May 23, 2017
Medway Planning and Economic Development Board
155 Village Street
Medway, MA 02053

Merrimack Building Supply Site Plan – Public Hearing Continuation

RE: Merrimack Building Supply, Medway, MA
Major Site Plan Review

The following is Guerriere & Halnon, Inc.'s (G&H) responses to comments by Tetra Tech (TT) dated April 20, 2017. We have reiterated TT's comments with G&H's response following each comment.

LOCUS MAP

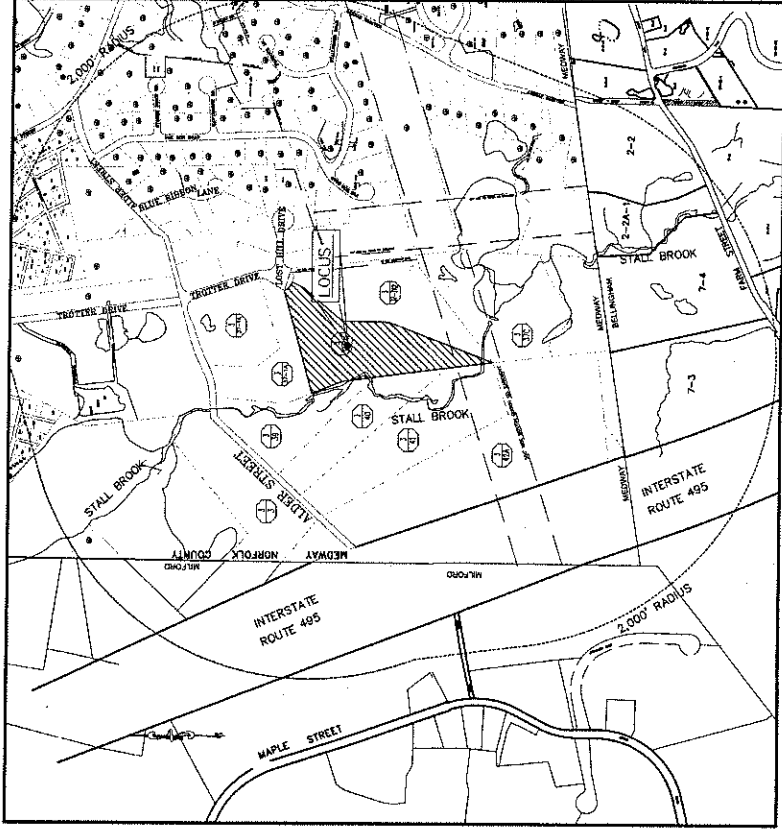
34. Content of Locus Map on Cover Sheet is not consistent and does not provide clear coverage of area. We request the Locus Map be compiled from a single source.
The Locus Map has been revised.

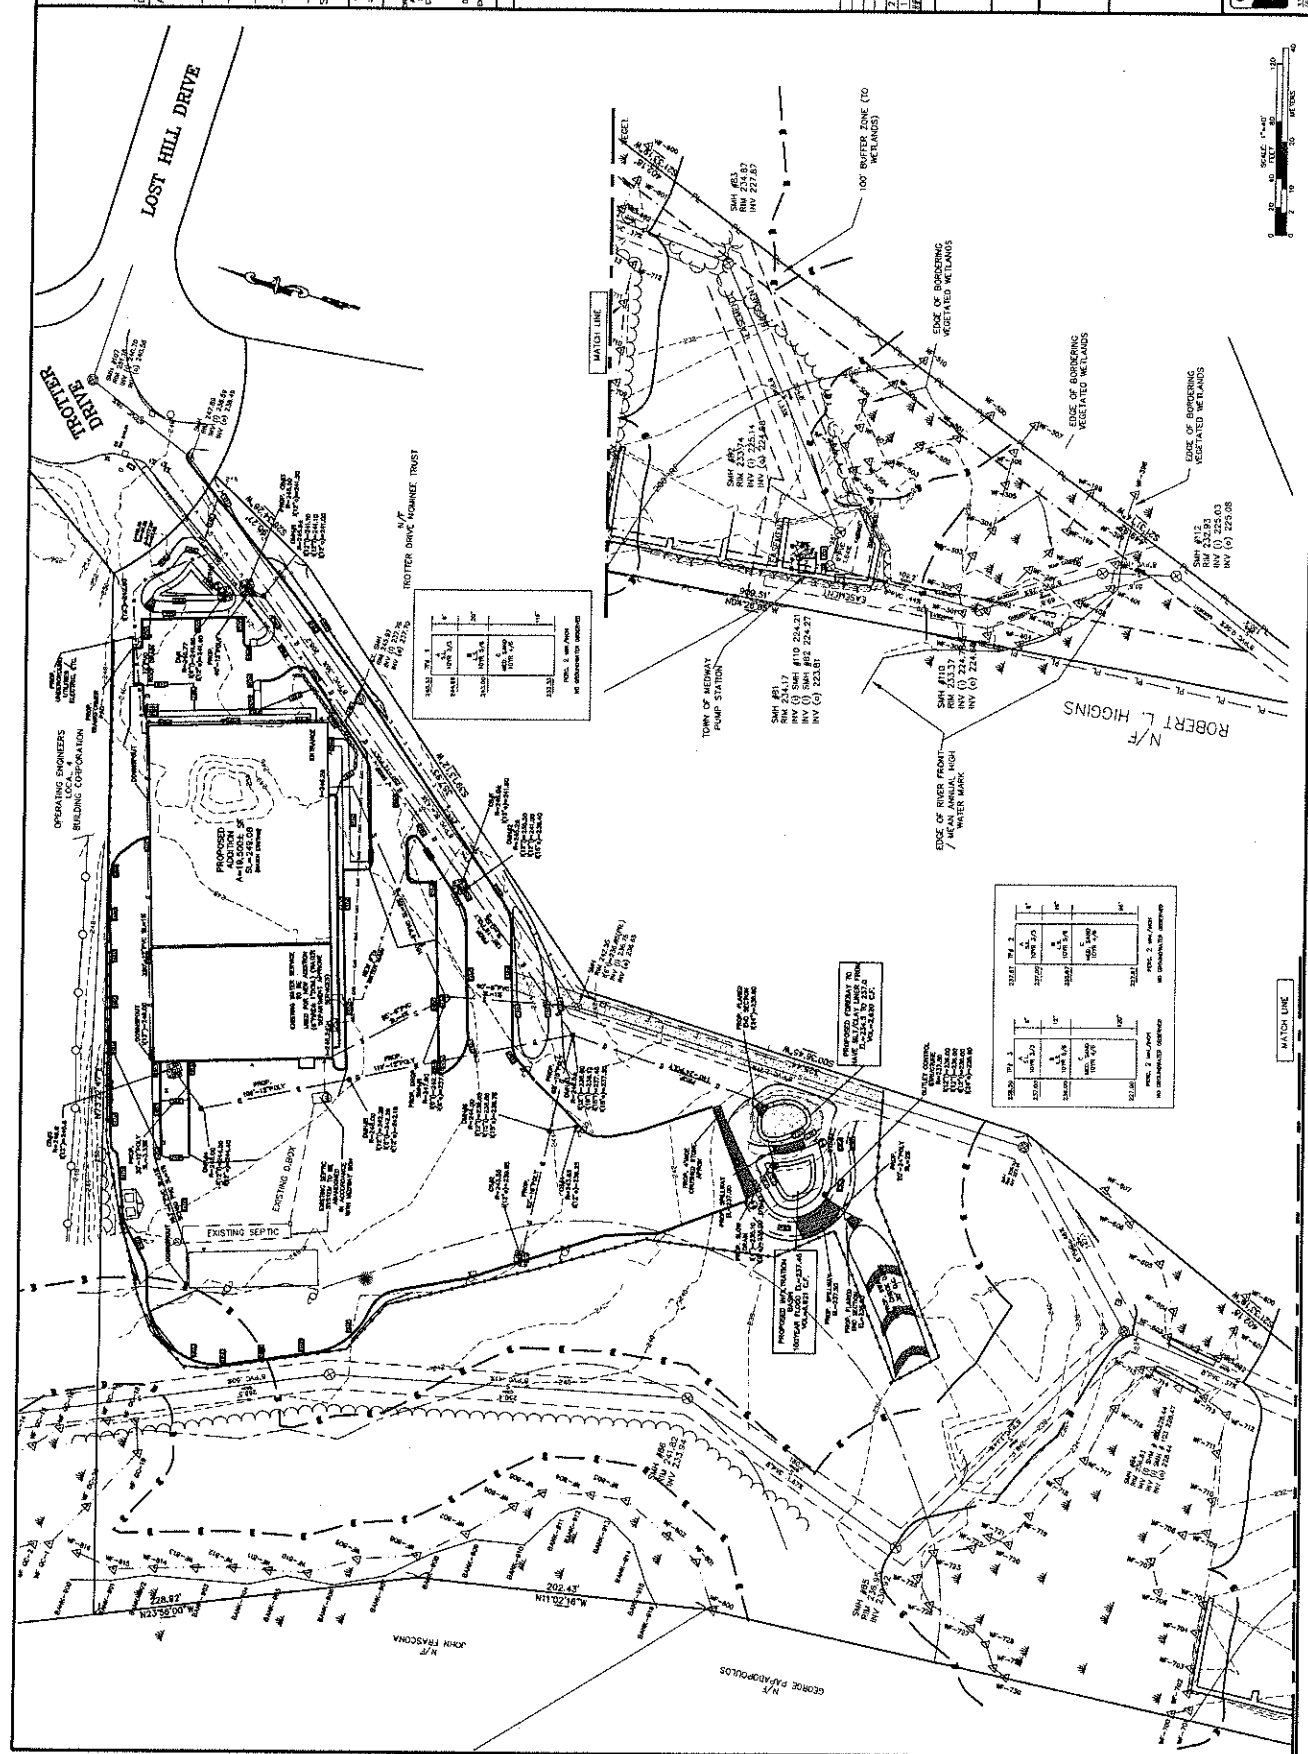
2. Site plans are required to be drawn at a scale of 1"=40'. Plans provided are at a scale of 1"=30' and do not show the entire site. We appreciate the level of detail and clarity provided by the 1"=30' scale but recommend the plans be reformatted to show the entire site.
The plans have been revised to be at a scale of 1"=40'.

4. The plans do not show setback lines.
The Site Plan sheet has been revised to show the setback lines.
5. The plans do not show proposed curb radii for parking areas.
The Site Plan has been revised to show the curb radii for the parking areas.

6. Existing/Proposed dumpster location and screening are not shown on the plans.
The dumpster & screening locations have been added to the Existing Conditions & Site Plan.

11. It appears the proposed internal site driveway is located within 15-feet from a side lot line.
The plan has been revised to relocate the proposed driveway outside the 15' from lot line.

13. The plans do not distinguish between employee parking and customer parking areas.
The Site Plan has been revised to label the employee and customer parking areas.

14. It appears the applicant is providing greater than the required parking for the site. We recommend the applicant limit parking to only what is required, if possible, in order to reduce impervious area.
The Site Plan has been revised to reduce the parking and impervious area.

15. Proposed parking stalls are designed at 9'x18' and include a "±" designation. The regulations require stalls to be no smaller than 10'x20'.
The Site Plan has been revised to reflect parking stalls to be 10'x20'.

16. Wheel stops are required at the head of parking stalls that abut pedestrian sidewalks.
The Site Plan has been revised to add wheel stops at the head of parking stalls that abut pedestrian sidewalks.

17. It appears the parking area to the east of the proposed building is located within 15' of a side lot line.
The plans have been revised to relocate the parking area to the east of the proposed building.
